Value Engineering Study
WWTP #2 Improvements
Coos Bay, OR

FINAL VALUE ENGINEERING STUDY REPORT

WWTP #2 IMPROVEMENTS

Coos Bay, OR

Baseline Sketch

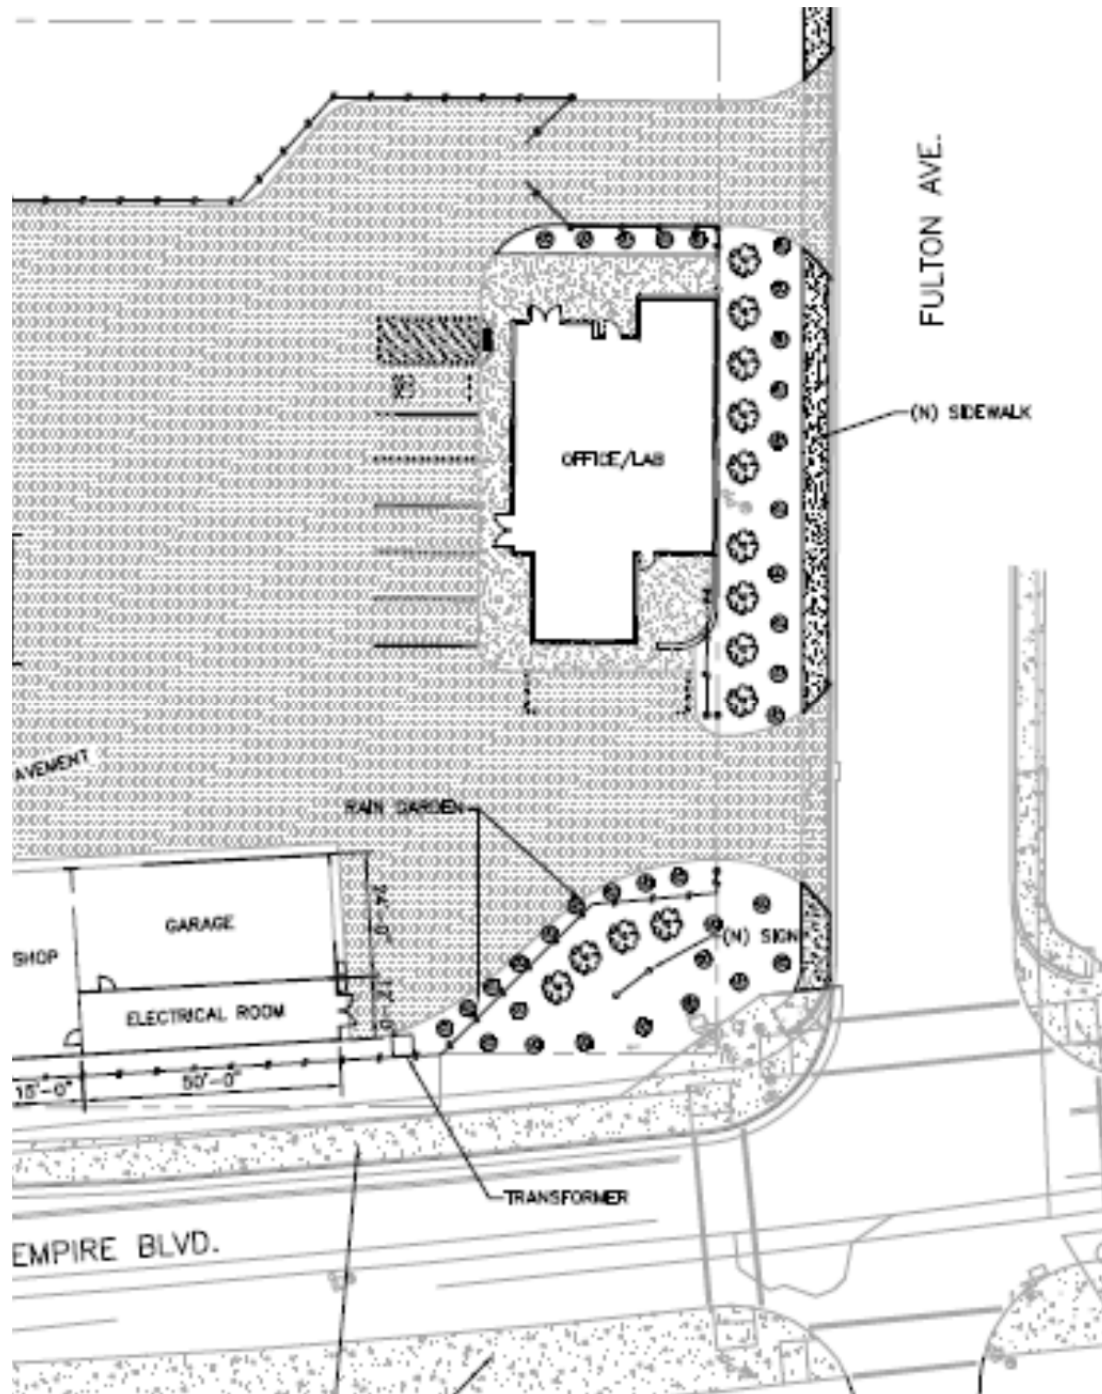
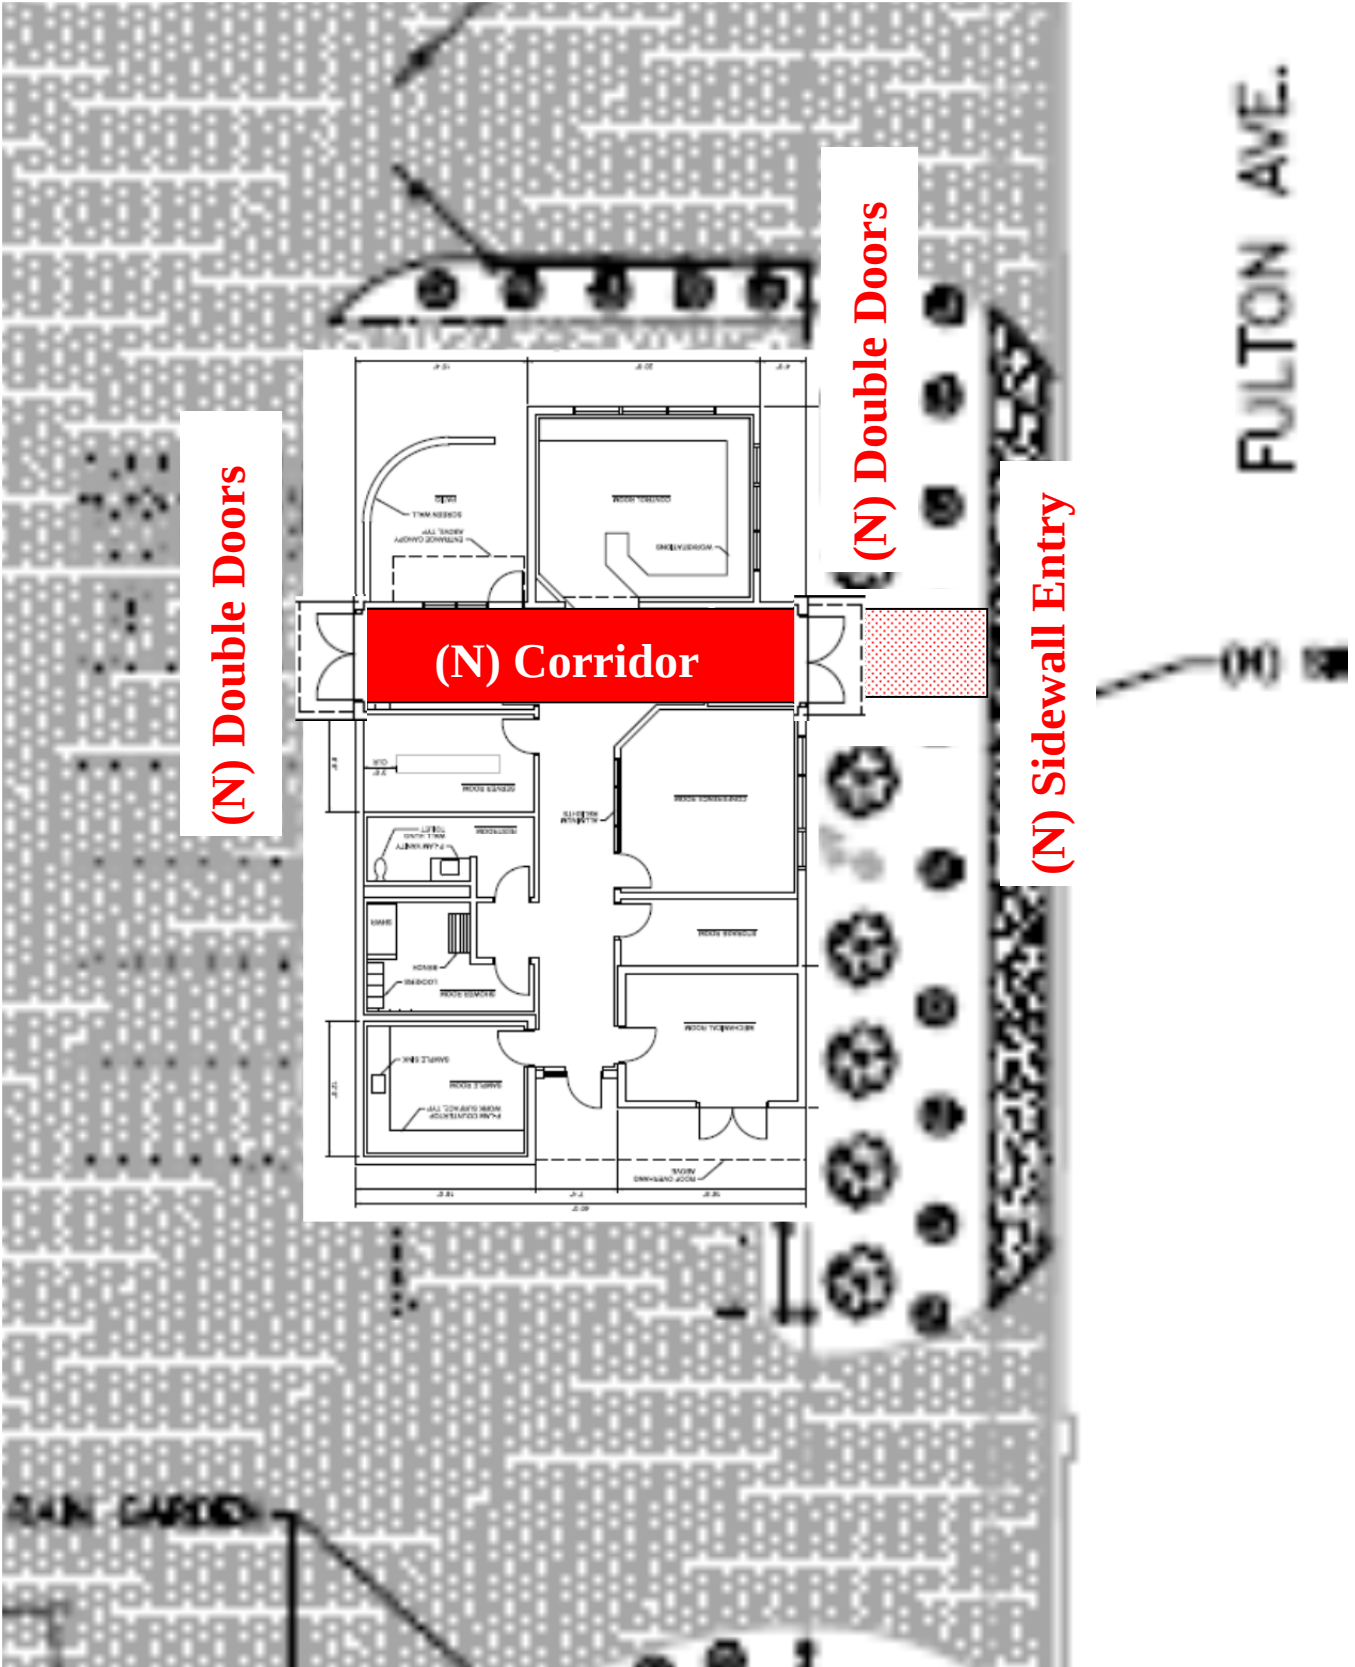
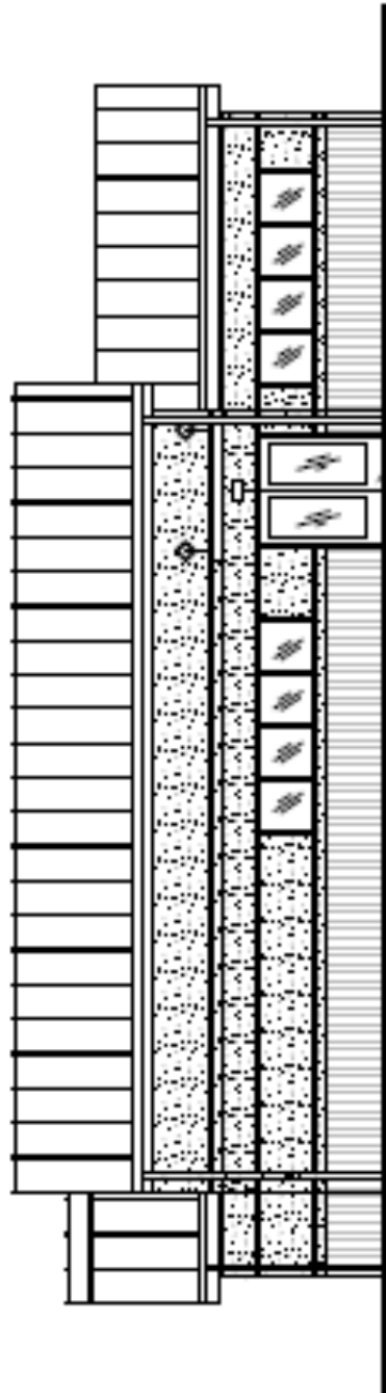
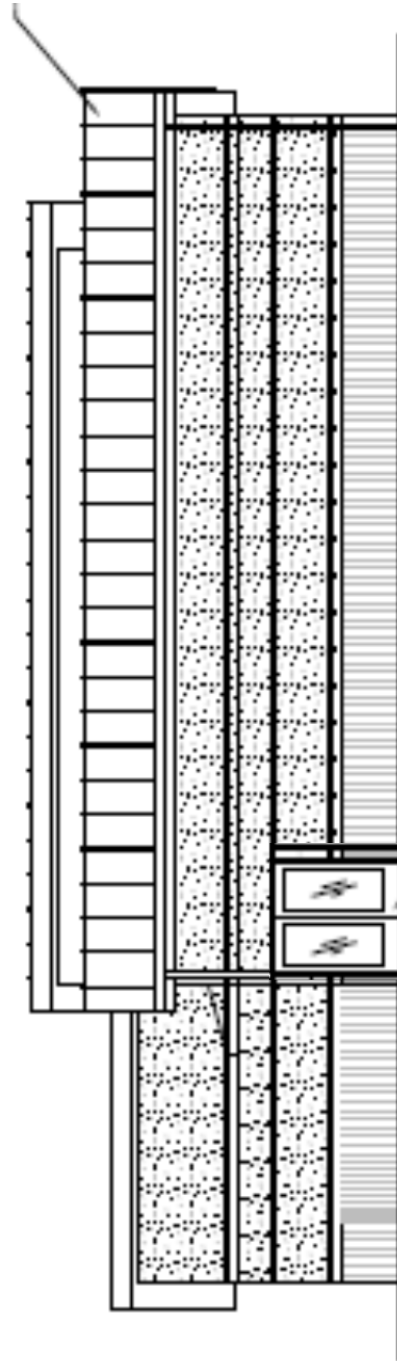
The alternative concept would be to rotate the building 180 degrees and provide a visitor/public entrance to the building from the south side along Fulton Avenue and a second staff entrance on the north side of the building.

The baseline concept is for the Control Building with a single Staff and Visitor Entrance on the North side of the building. The alternative concept would be to rotate the building 180 degrees and provide a Visitor/Public entrance to the building from the south side along Fulton Avenue and a second Staff entrance on the north side of the building. Creates a building in the community which is inviting to visitors from sidewalk/street. Replaces the flat/blank south elevation from facing the public along Fulton Ave. with the doors and windows of the North elevation. By separating the public/visitor entrance from the staff entrance keeps public/visitor entrance clean. Requires adjustment in the layout of the interior space of the building for a second entrance. Decreases security by placing doors and windows along the sidewalk and street side along Fulton Avenue. The layout of the interior spaces should be modified to relocate the control room to serve as a control point for visitor/public entry as well as observe the plant.

Baseline Sketch

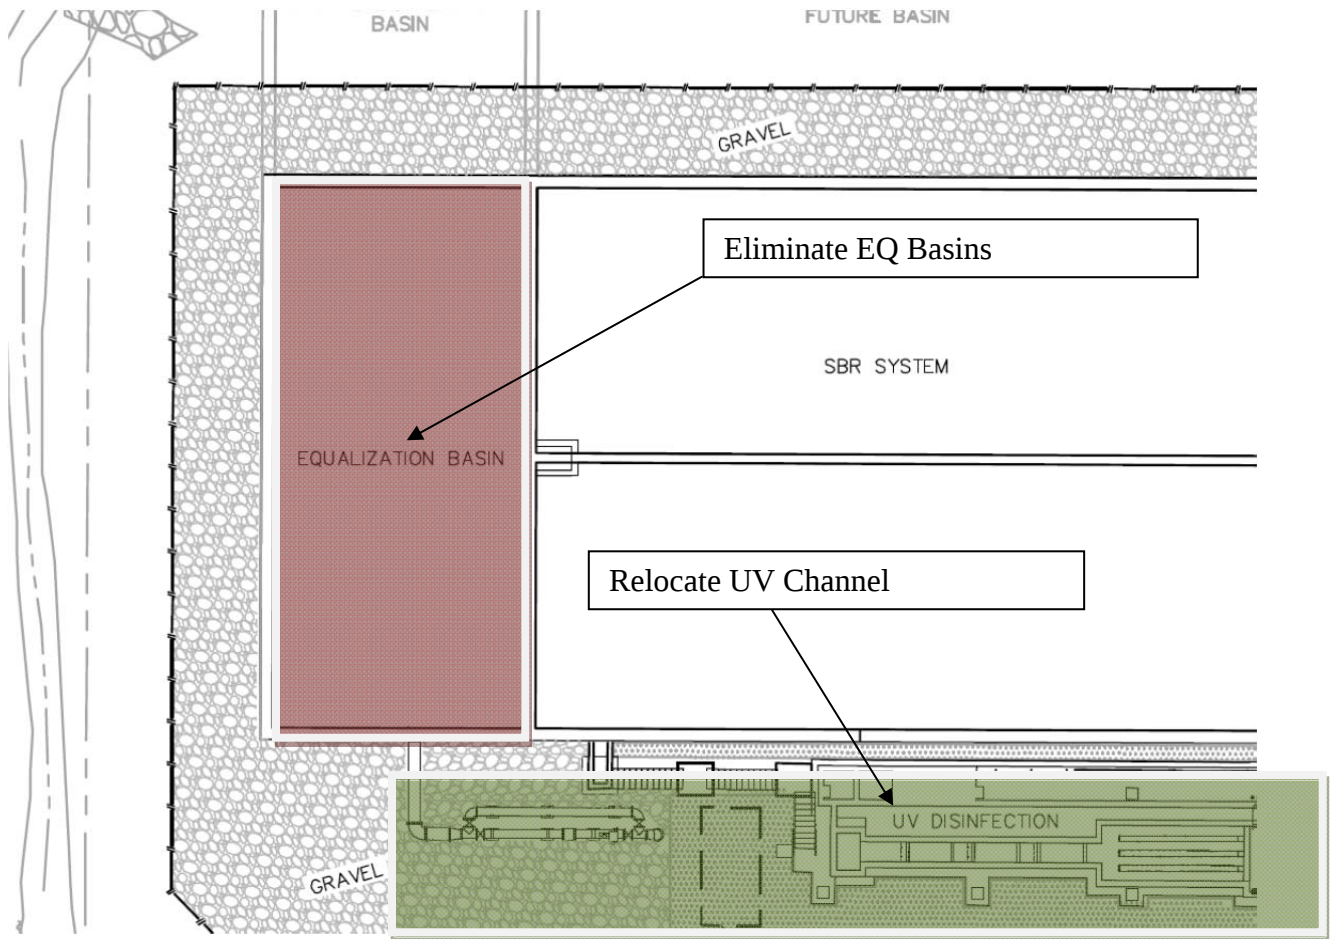
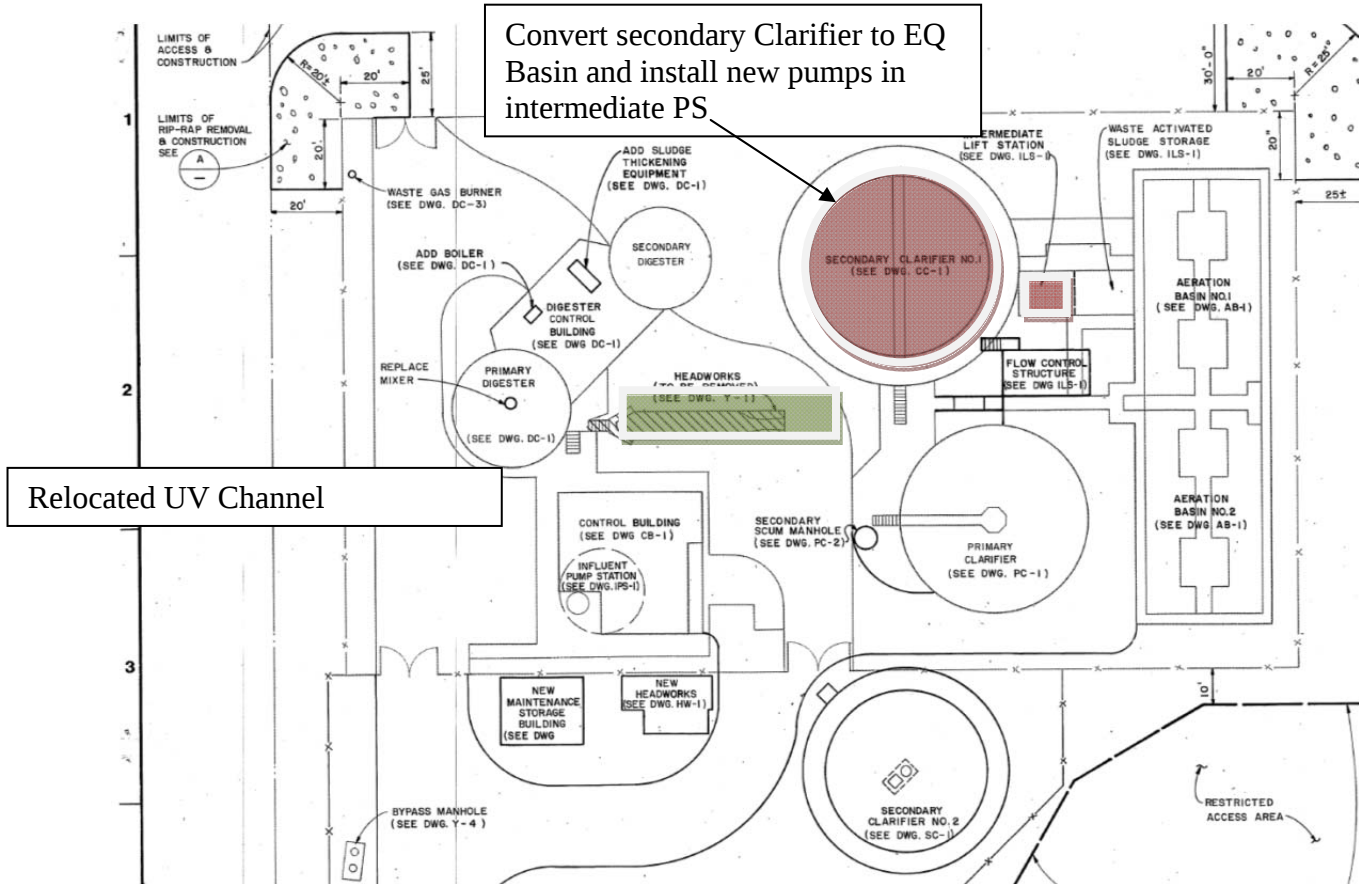
This alternative attempts to take advantage of existing assets (concrete tanks) that can provide long-term solutions to the needs of the new treatment process. The disadvantage of the alternative is that the existing secondary tanks at located below the hydraulic grade that would allow for gravity flow through the outfall. This alternative will require pumping to use the existing outfall.

Eliminating the proposed EQ storage basins eliminates 3,600 square feet of slab area, 272 linear feet of footings, and 272 linear feet of concrete walls (23 feet tall) at the SBR. This eliminates approximately 960 cubic yards of new concrete (slab – 540 CY, footings – 120 CY, Walls – 300 CY).

Reusing the secondary clarifier will require the removal of the mechanical equipment and some new piping to connect the clarifiers to the discharge pipeline from the new plant and some discharge piping to connect the intermediate pump station to the relocated UV channel. The clarifier would need to be covered to prevent algae growth in the basin.

The relocation of the EQ storage to the existing plant site will also require the relocation of the UV process. The UV channel as designed could be moved to the existing site but the ground elevation at the new site is at approximately 14 feet. The elevation of the top of the concrete channel needs to be at a minimum of 22 feet. The ground elevation at the proposed elevation of the UV channel is 15 feet. The UV channel could be accommodated at the existing site with minimal changes.

This alternative also allows the design to incorporate a lower elevation for the SBR and Headworks at the new plant site. This reduces construction costs and reduces the visual impacts of the headworks and SBR. Since the alternative equalization basin is approximately 12 feet lower than the proposed equalization basin the hydraulic profile of the headworks and SBR can be lowered at the new plant site. The geotechnical report recommends remove unsuitable fill material to approximately elevation 9.0 feet at the new site and then backfilling with 6 feet of imported fill material to raise the SBR and headworks to the proper elevation (elevation 15.0 feet) for the proposed hydraulic grade line. If the alternate equalization basins are used it will not be necessary to bring in the 6 feet of structural fill material and the bottom SBR can be at elevation 9.0 feet. The top elevation of the headworks would be lowered from approximately elevation 63.0 feet to elevation 57.0 feet. The savings will include the structural fill for backfilling the site to a higher elevation.

Once the headworks and SBR are constructed at a lower elevation it will reduce the size of the pumps in the influent pump station. The influent pumps are designed to pump against 53 feet of total dynamic head at peak flow conditions. The TDH would be reduced to 47 feet in peak flow conditions. This change may impact pump sizing and will reduce energy use in the influent pump station by approximately 20% annually.

Option A:

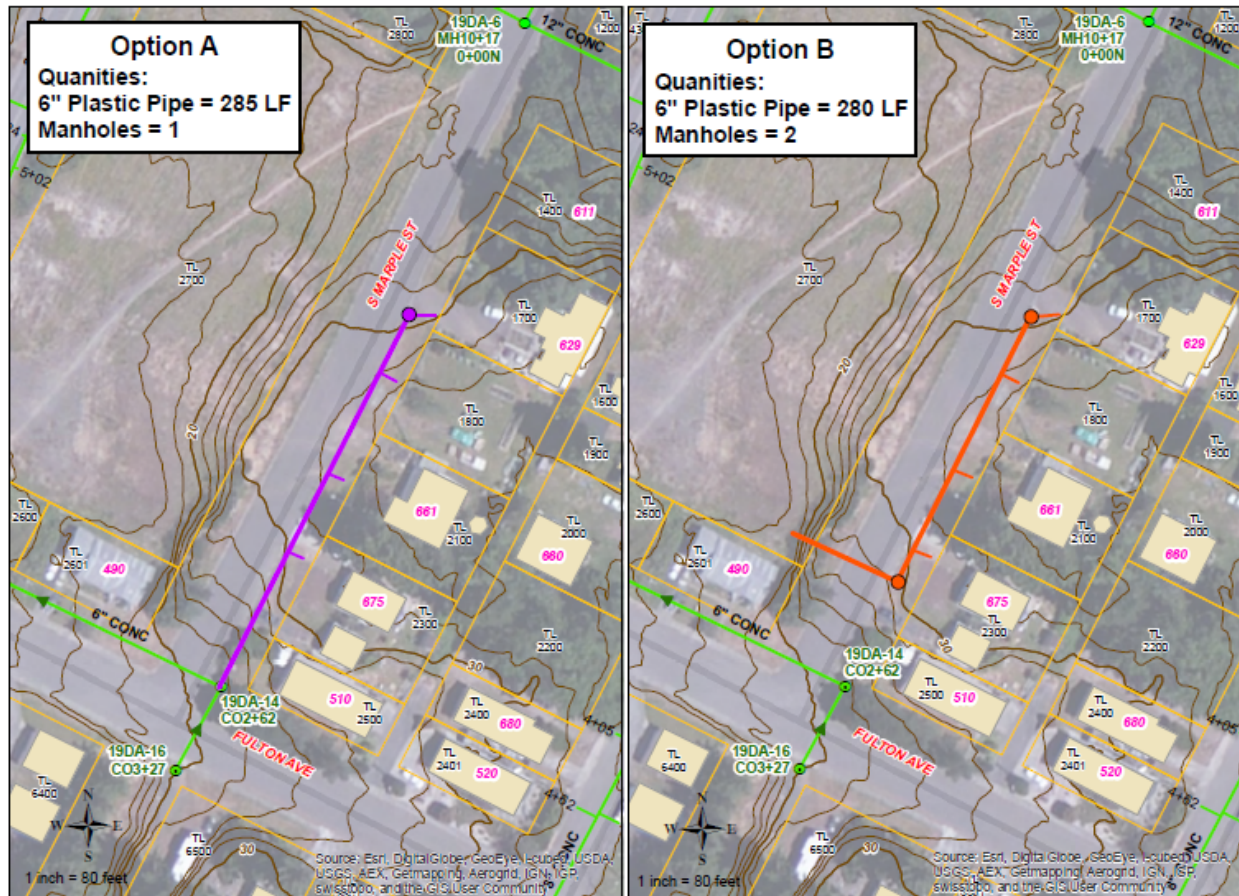
There is an existing 6 inch concrete gravity sewer line along Fulton between Empire Blvd and S. Marple Street. However that line is shallow (exact depths not known at this time). A 6 inch gravity line can be installed within the easterly portion of the right of way and out of the traveled lane (to reduce costs). The line can be shallow (minimum 2 foot depth) and tie into the existing manhole located at the north east corner of the Fulton and Marple intersection.

This option does not address the future sewer service for 611 S. Marple. There is an existing sewer line that runs east to west at the intersection of Marple and the undeveloped Webster right of way. This existing line is approximately 60 feet from the northwest property corner for 611. This property is very constrained from a development standpoint. The majority of this property has a creek bisecting it and will require environmental processing for any development. If this property is eventually developed the City will allow the property owner to install a lateral along Marple that will extend from the property to the existing sewer line at Marple and Webster.

Option B:

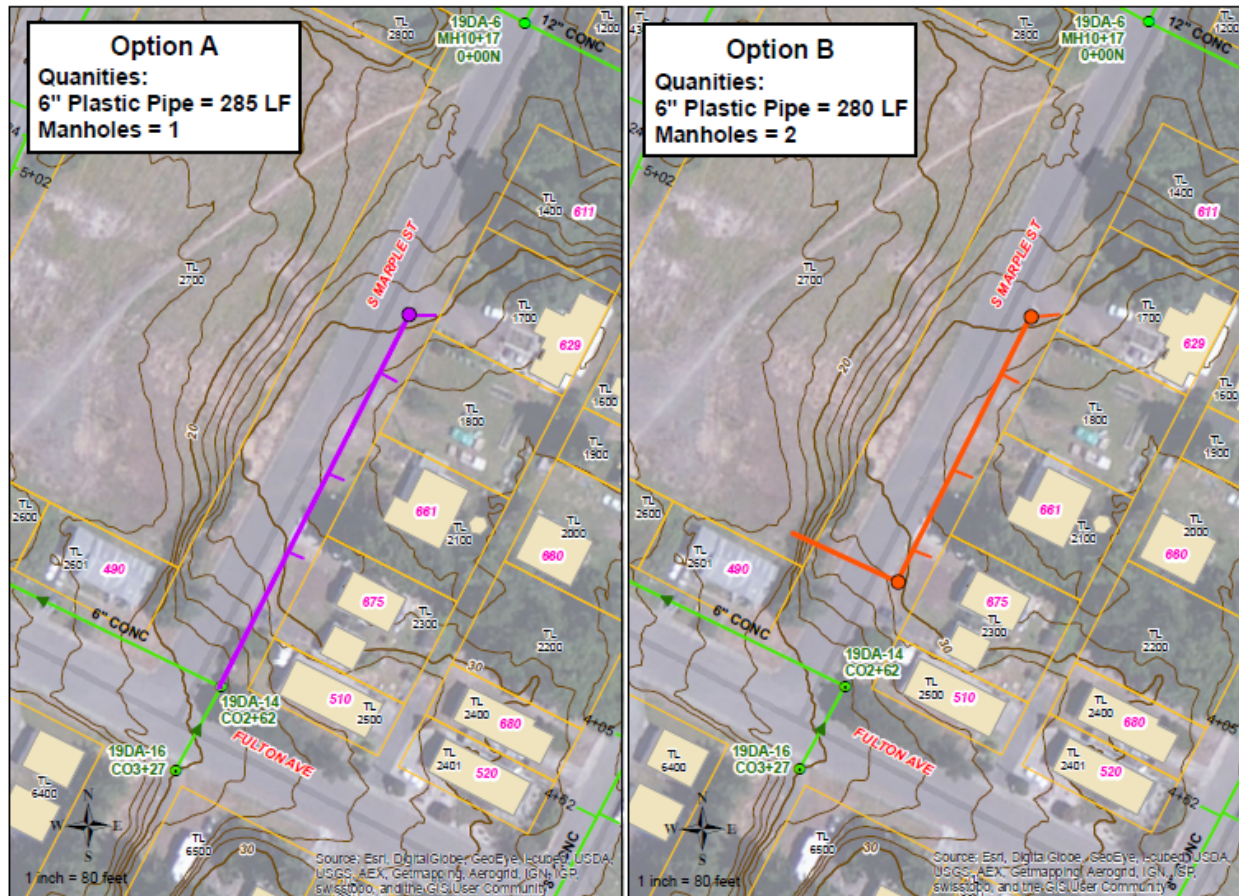
If this proposed line cannot gravity to the existing manhole at Fulton and Marple, then the line can cut across Marple in front of 675 S. Marple and tie into the plant.
